Access Compliance Report Public Rights-of-Way (Curb Ramps)

Main Street: MAIN_ST Cross Street: CHIMNEY_LN Location: NW

ADA ID: RPRK211101131916 Ramp Type: Type 4 - Parallel Initial Pass/Fail: Fail Overall Compliance: No Severity Score: 15

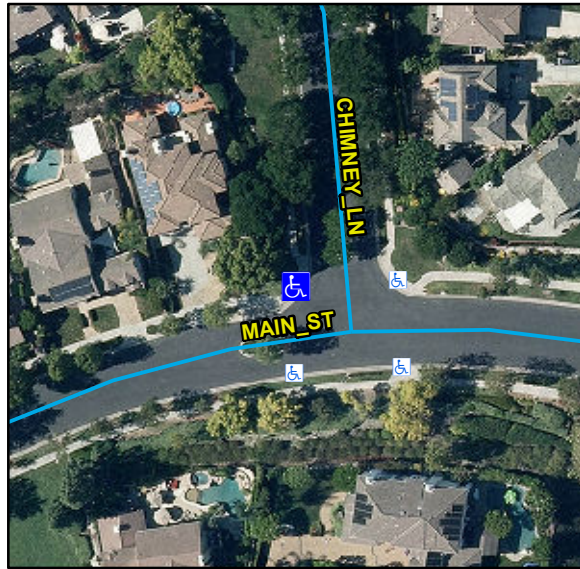
R204.3, R304.3.2, STD 1115

Remove & Replace Curb Ramp With Two New Directional Ramps or Equivalent.
